Item 7.**Development Application: 107-109 Darlinghurst Road, Potts Point - D/2022/1107**

File No.: D/2022/1107

Proposal Summary: Consent is sought for alterations and additions to an existing mixed use building above Kings Cross Station, including construction of two additional levels.

Figure 31: Three dimensional height plane illustrating elements of the proposed development in breach of the Sydney Local Environmental Plan 2012 22 metre Height of Buildings development standard

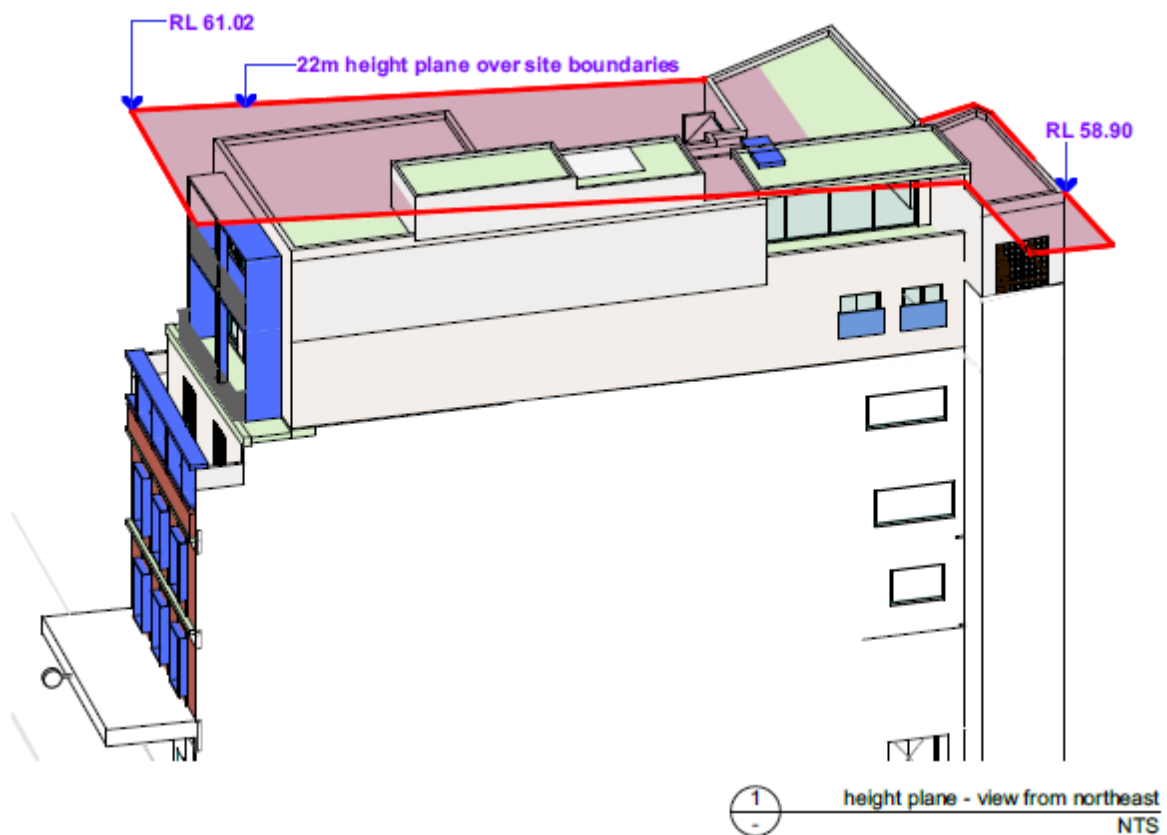
81. Council officers do not share the view that the proposal is compatible with the character of the streetscape and surrounding heritage conservation area.
82. The breach of the height of buildings standard contributes to the bulk and massing of the building, although the elements of the development in breach of the standard are setback from the building frontage and not highly visible from the public domain, as illustrated by figure 31 below.

83. Similarly, council officers do not share the view that the proposal presents a high-quality built form, or that it does not compromise the amenity of locality, however the elements of the proposed development in breach of the height of buildings standard are not principally attributed with these impacts.

Figure 32: View from the sun diagrams demonstrating additional overshadowing impacts to the living room windows of Unit 4.12 within the Omnia building adjacent - highlighted in red

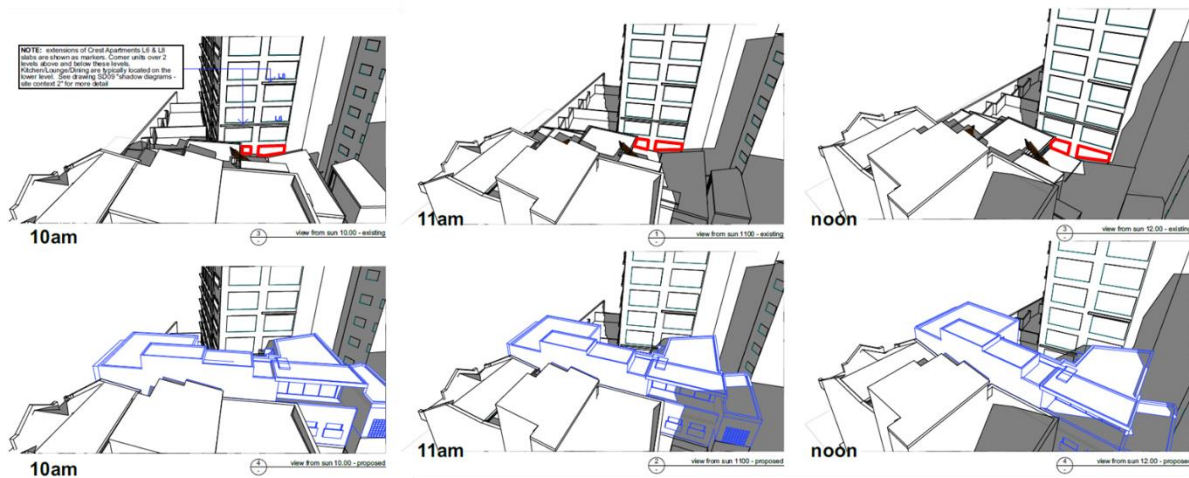
103. Unit 4.12 currently receives 2 hours' direct solar access to its north facing living room windows between 10am and 12 midday on 21 June.
104. The proposed development and additional two levels proposed atop of the existing building will block all direct sunlight these living room windows currently receive between 9am and 3pm on 21 June resulting in a non-compliance with the provisions of the DCP.

105. Overshadowing impacts to these living room windows are demonstrated by Figure 32 below, with the living room windows in question highlighted in red.

Figure 33: View from the sun diagrams demonstrating additional overshadowing impacts to the terraces of Unit 3.02 and Unit 3.03 on the podium level of the Omnia building adjacent - terrace areas highlighted in green

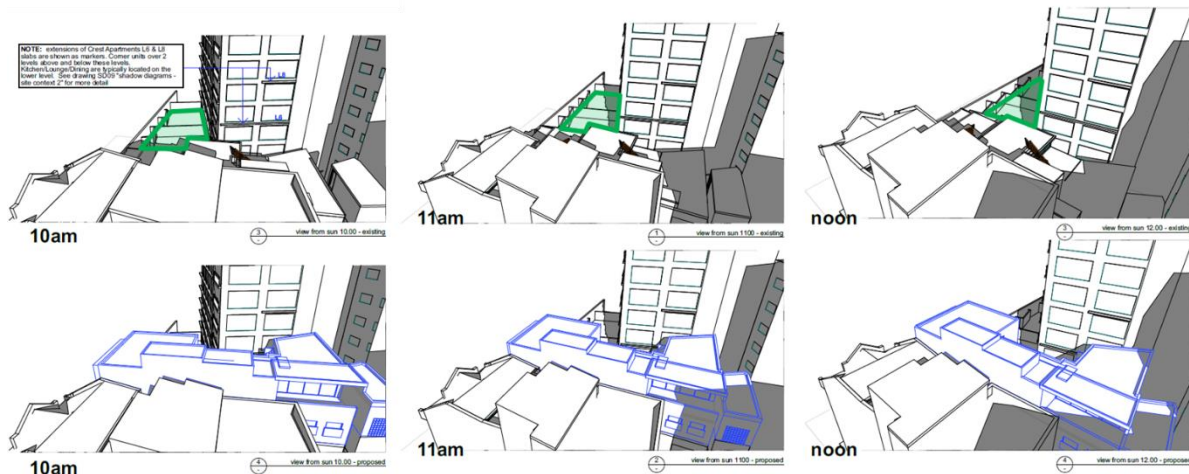
112. Whilst the applicant has not provided dimensions to measure existing solar access to this space, it is noted that the terrace measures 79 square metres and it is considered that the terrace will comfortably achieve the minimum 5 square metres direct sunlight for at least 2-hours as existing.

113. The proposed development and additional two levels proposed atop of the existing building will block almost all direct sunlight to these private open space areas during the morning hours between 9am and 12midday on 21 June.
114. This is the only time of day the terrace areas currently receive direct sunlight, resulting in a non-compliance with Section 4.2.3.1 of the DCP.
115. Overshadowing impacts to these private open space areas is demonstrated by Figure 33 below, with the terraces of Unit 3.02 and Unit 3.03 highlighted in green.
